Technical Note 1

Land to the east of St Nicholas - Planning Ref: 2016/00619/FUL

2. This Technical Note has been produced in response to comments received from the Vale of Glamorgan's (VoG) Highway Officer (dated 20th July 2016), in relation to the proposed site access options. These comments are contained in **Appendix A**.

DRAWING NUMBER: W141341_A08	REVISION: B
---------------------------------------	-----------------------

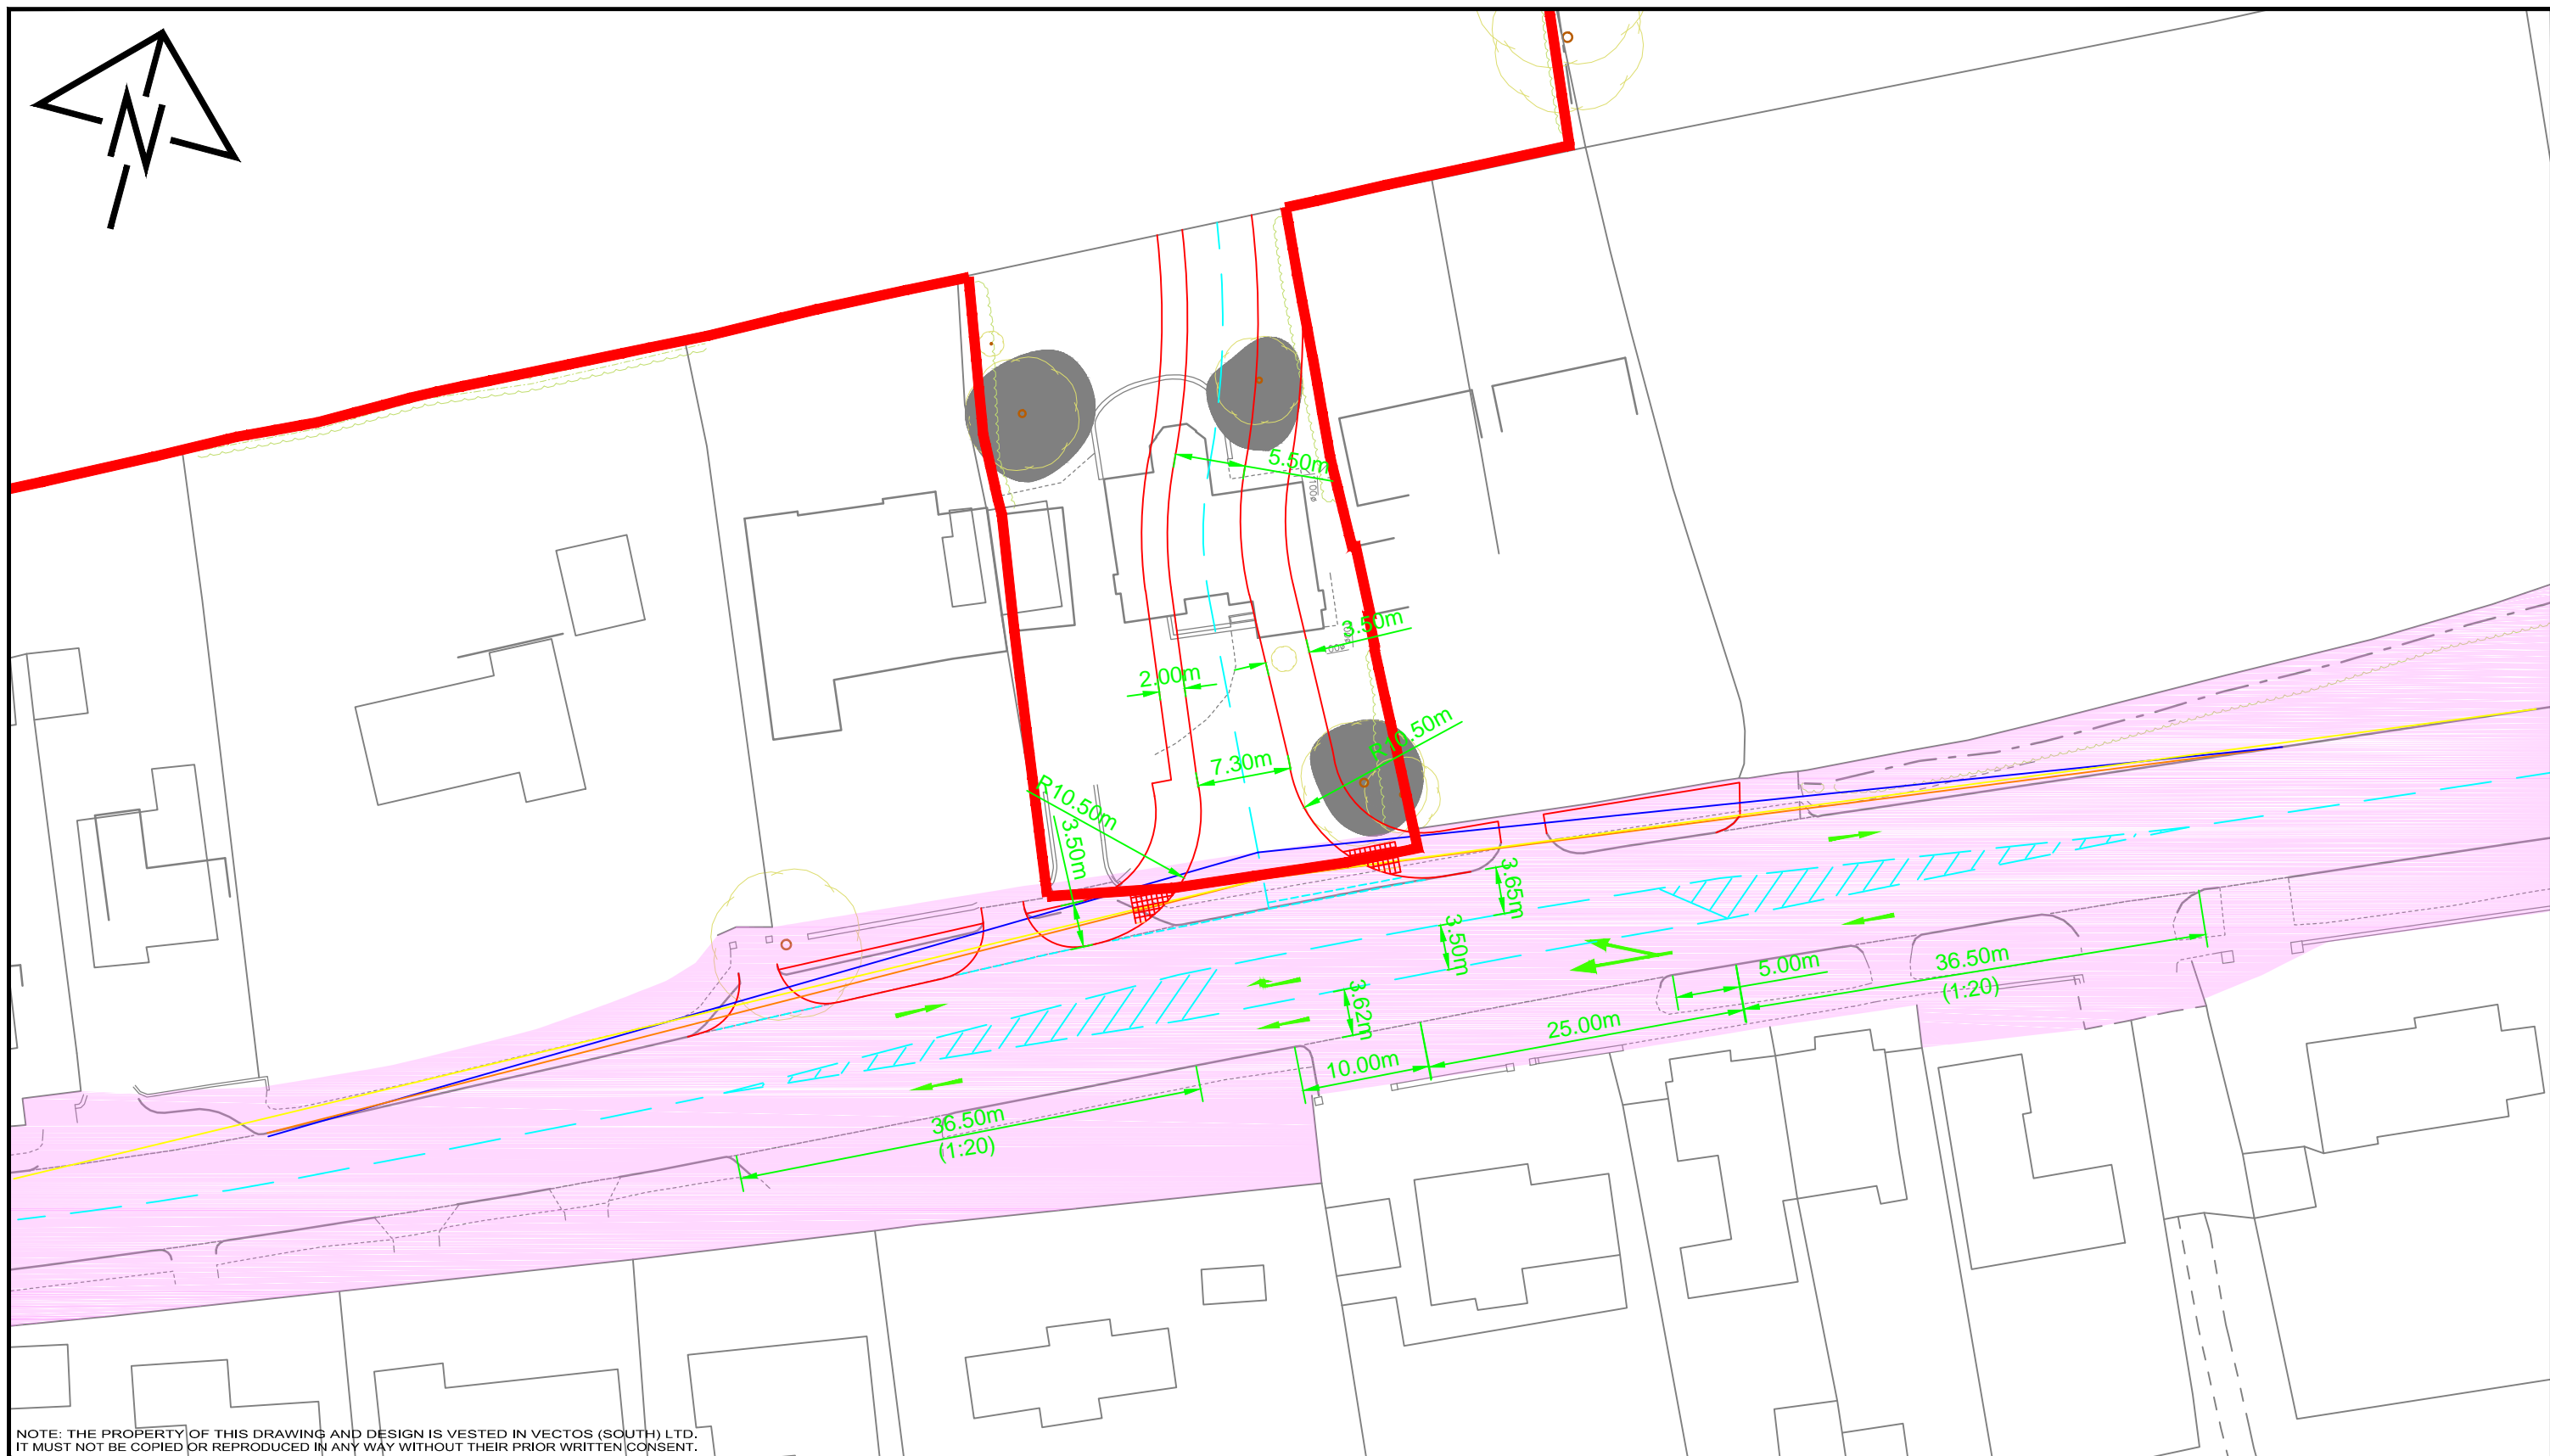
1. The junction radii being increased to 10.5 metre (minimum)
2. The access width being 5.5m
3. Visibility Splays 100m x 4.5m in Both Directions based on the Desirable Minimum Safe Stopping Distance and reduction to the absolute Minimum o SSD of 80m will need justification.
4. Submission of comprehensive swept path analysis of the junction area allowing for the movements of 11m ridged vehicles entering / exiting the site while there is a vehicle sighted at the minor arm junction.

5. The revised junction arrangements for Option 1 are contained within **Appendix B**.
6. The Highway Officer requested that the corner radii be increased to 10.5m to accommodate larger refuse vehicles. This has been accommodated within the revised junction design.
7. The width of the access road has been increased to 7.3m to accommodate the swept path of a large refuse vehicle. The access road narrows to 5.5m as it enters the site.
8. Swept path Plans are contained in **Appendix B**. These plans demonstrate that:
 - (Plan H01) - A large refuse vehicle (9.86m in length) can easily access and egress the site access junction;

11. There is no reason why the minimum SSD should not be used in this location as the review of accident statistics contained in the Vectos TS demonstrate that there is an excellent accident record on this section of the A48. The plans contained in **Appendix B** illustrate that the minimum visibility requirements at 4.5m back from the give-way line (X distance) can be achieved in both directions using the advised methodology in MfS2 (Para 10.5.3).

12. However, MfS2 recommends that the distance from the give-way lines at which visibility splays are measured, should be only 2.4m, not 4.5m. At an X distance of 2.4m, the plans contained in **Appendix B** illustrate that the desirable visibility requirements can be achieved in both directions using the advised methodology in MfS2 (Para 10.5.3).
